## **APPENDIX I-7**

### **Response to AECOM Memo of September 16, 2020**

**Dynamic Earth**

**RE: The Preserve at Indian Hills**  
21 Breeze Hill Road  
Northport, Town of Huntington  
Suffolk County, NY  
Dynamic Earth Job# 3114-99-001EC

Figure 1. Topographic Profile along Three Borings

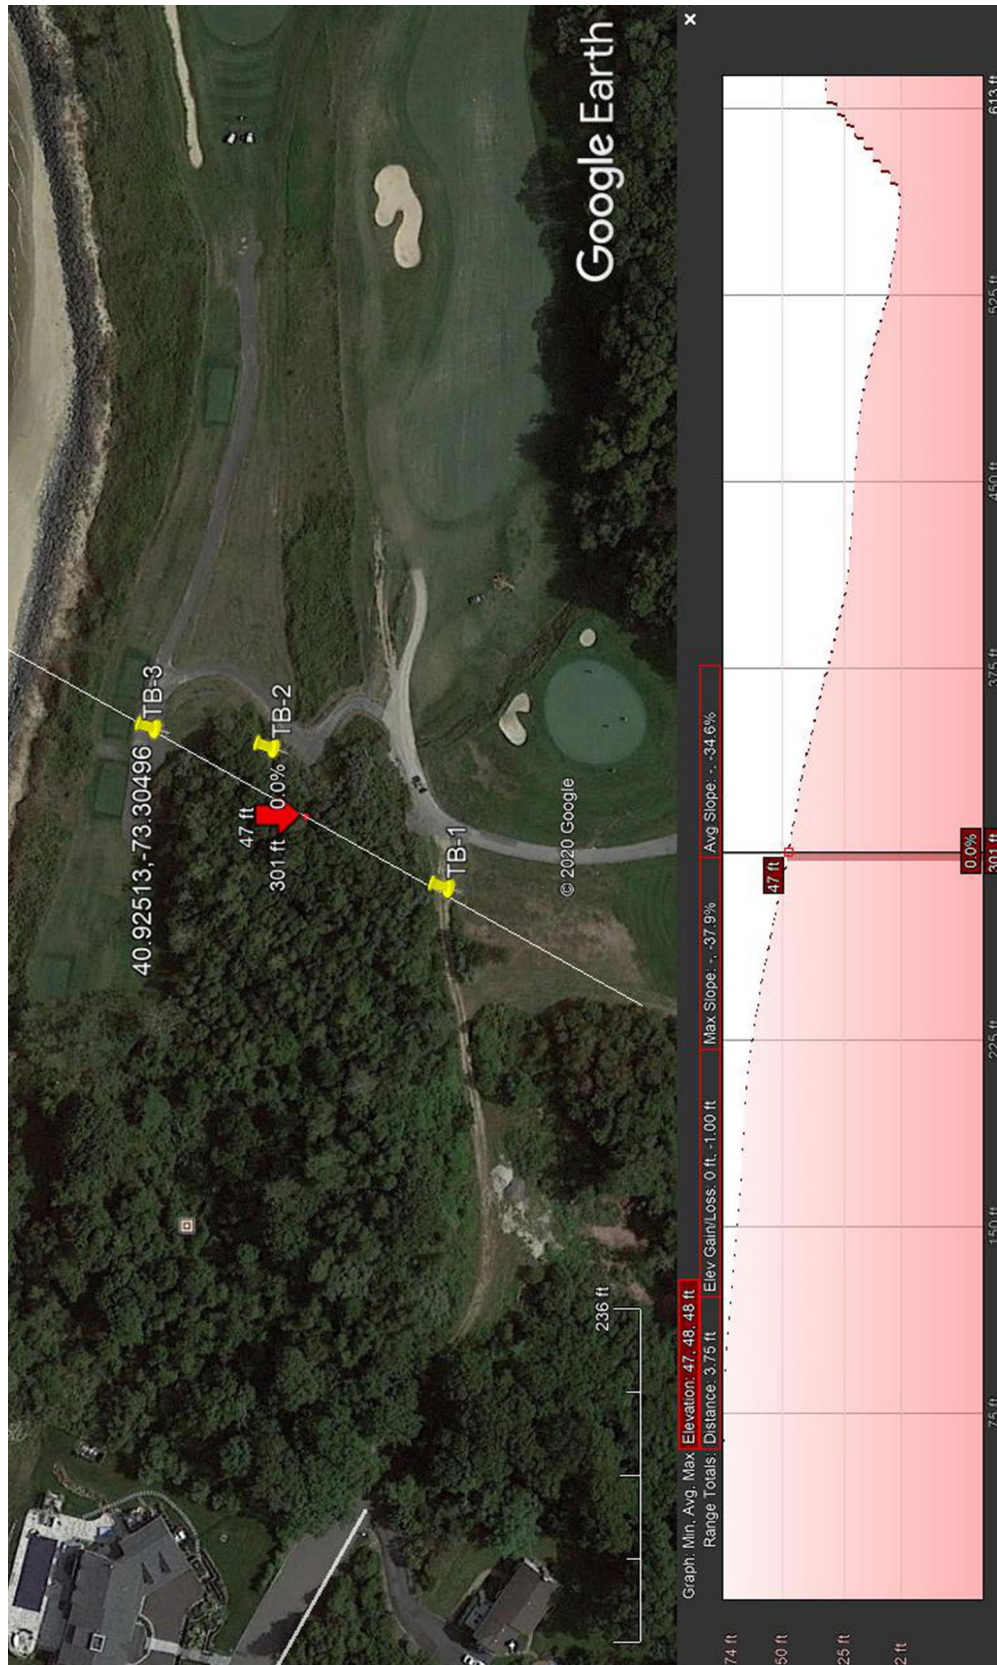
Based on the new data from 3 borings shown on Figure 1 and lab tests, we reduced the cohesion of the Gardiners clay deposit from 650 psf to 500 psf in our simplified analysis and raised the water table to approximate Elevation +50 in the pre-existing landslide area. This conservative approach indicates a Factor of Safety greater than 1.3 as we previously recommended with the 300 psf surcharge of the buildings.
